# PD Modification Application: PRS 25-0115

**Hillsborough  
County Florida**

Development Services Department

PD 23-0882 was approved in 2024 to allow for 63 single family residential lots. The applicant requests modifications to reduce the number of lots to 57, and to modify the approved layout to accommodate additional wetland and floodplain compensation needs. The applicant is also proposing to change the front and rear setbacks.

## 8.1 Approved Site Plan (Full)

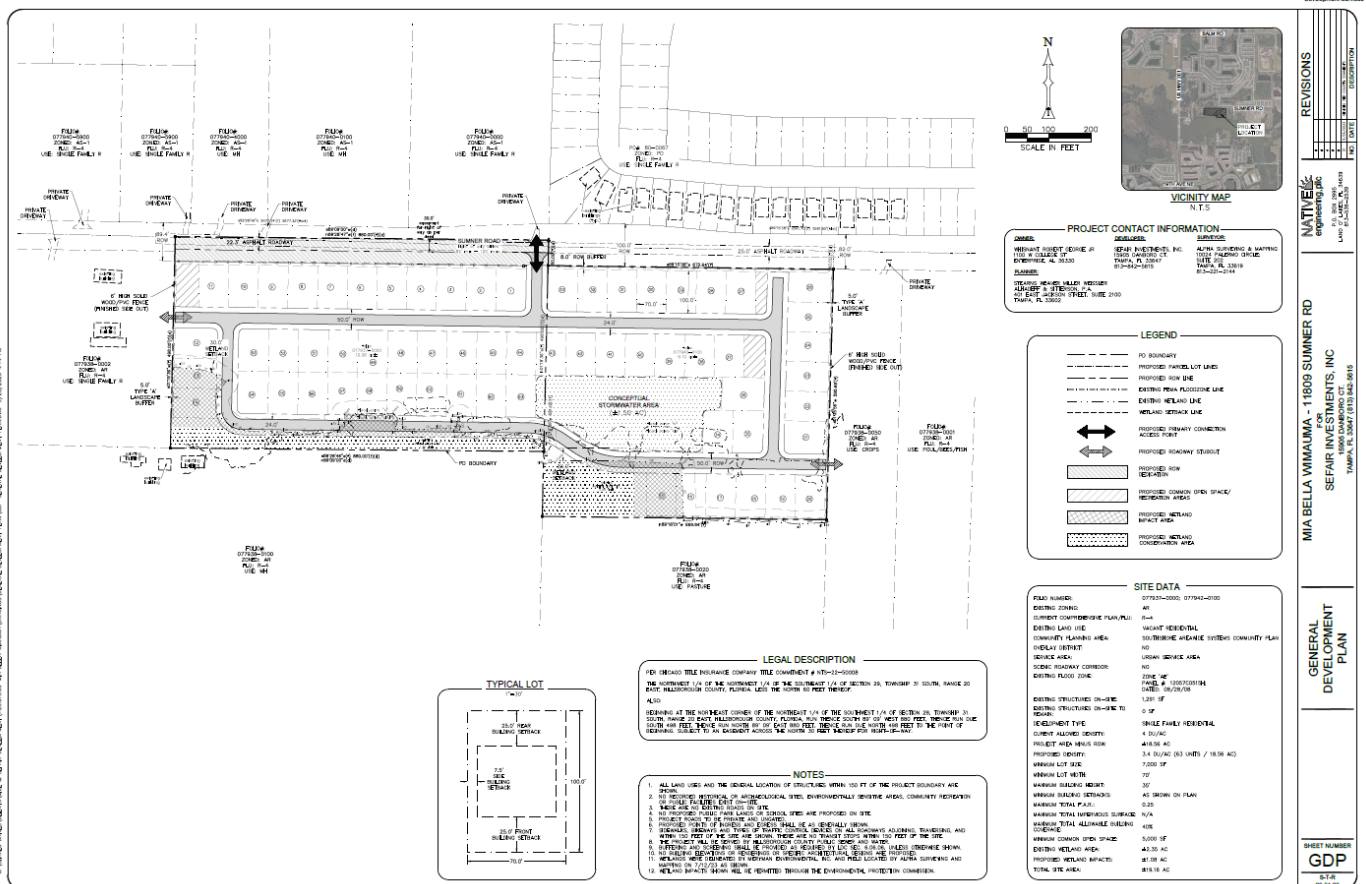
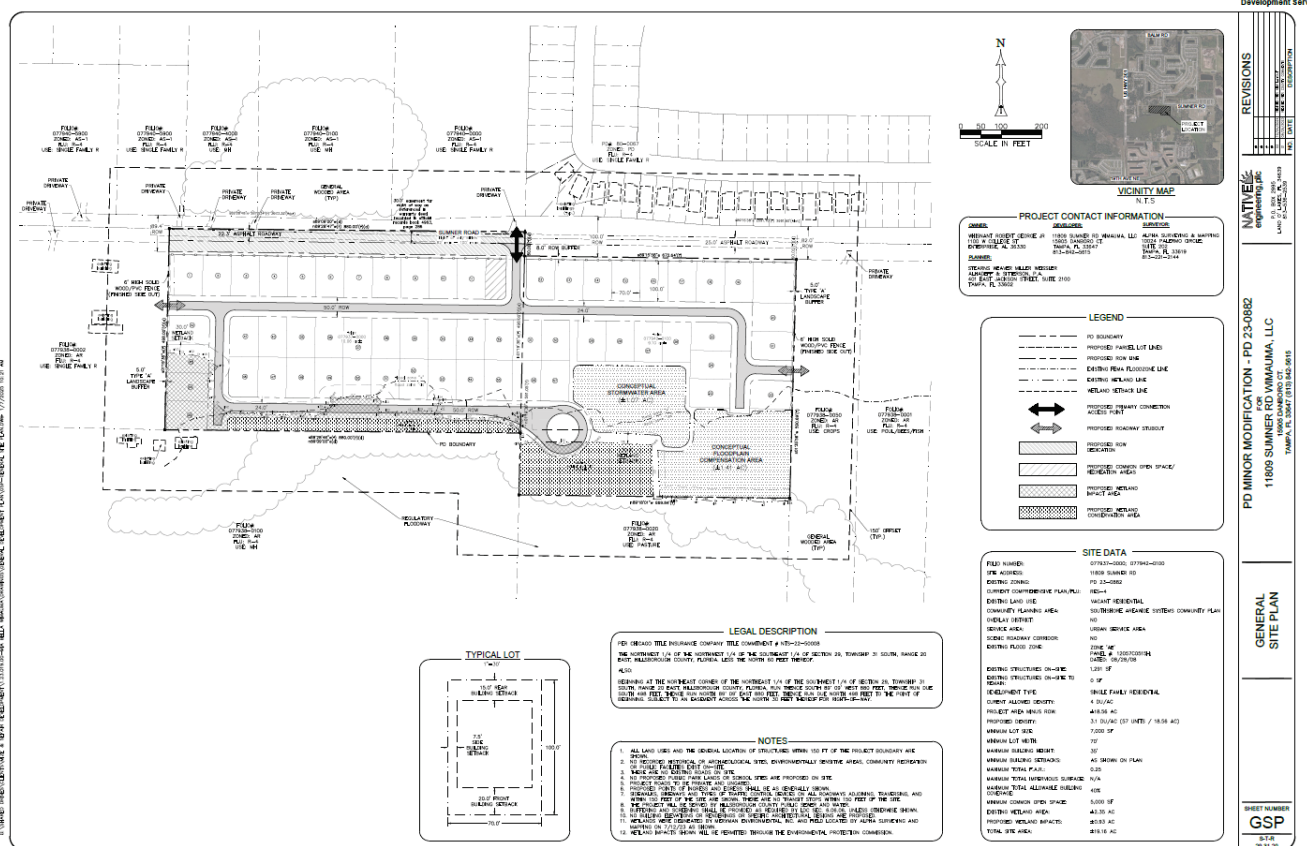
Existing Approval(s):	Proposed Modification(s):
63 single family residential lots	57 single family residential lots
Layout as approved by PD 23-0882	ROW pattern changes along the southeast portion of the development
Front yard setback of 25 feet for residential lots.	Reduce the front yard setback by 5 feet to a 20 foot front yard setback
Rear yard setback of 25 feet for residential lots.	Reduce the rear yard setback by 10 feet to a 15 foot rear yard setback

The proposed reduction to the rear setbacks would only impact the adjacent properties along the west and east PD boundaries. In addition, the PD conditions provide for an additional 5 feet wide buffer creating a total 20 feet distance to the adjacent properties.

**Approval** - Approval of the request, subject to the conditions listed below, is based on the general site plan submitted January 7, 2025.

- 7.1. A 30' wetland setback will be required from the limits of any approved wetland impacts. The southern road will be located within the 30' wetland setback area in the configuration shown on the current plans and may need to be relocated and/or compensation may be required.
